Fujitsu Microelectronics Europe
Functional Limitation Report

32-BIT MICROCONTROLLER **MB91460 SERIES**

FUNCTIONAL LIMITATION
EXTERNAL INTERRUPT
2006-11-27

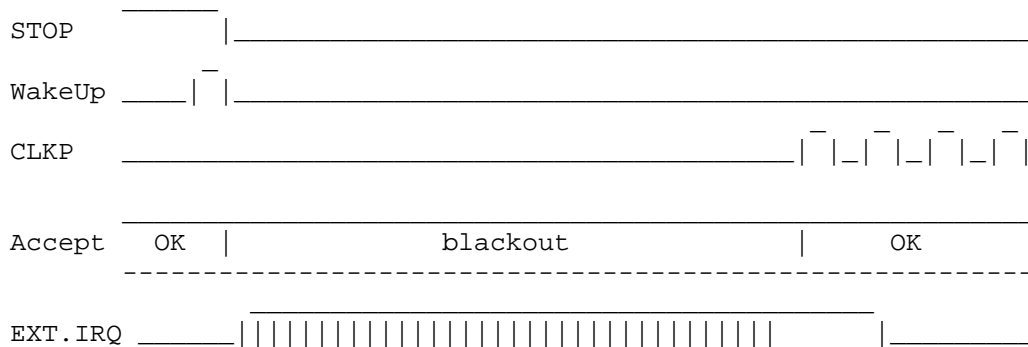
The problem occurs in the in the following constellation:

- MCU is waking up from STOP mode by either external interrupt trigger or internal RTC interrupt trigger (WakeUp)
- Oscillation stabilisation wait time is elapsing before internal clocks (CLKP) are feed-in to the external interrupt module
- The time frame between wake up trigger and the internal feed-in of clocks is called 'black out time'
- If one or more external interrupt events are supplied in the 'black out time' they neither set the related interrupt request flag nor start the interrupt processing (i.e. they are not accepted)
- The duration of the 'black out time' is depending on the selected oscillation stabilisation wait time (STCR_OS0, STCR_OS1) plus a fixed part of about 80us (for internal processing and regulator start up).

- The application uses only one interrupt source (either RTC or external interrupt) as wake up trigger
- The external interrupt signal needs to be long enough (in case of level) to be active after the black out time
- The external interrupt signal needs to be elongated by appropriate external circuitry (e.g. monoflop) in case of short pulse
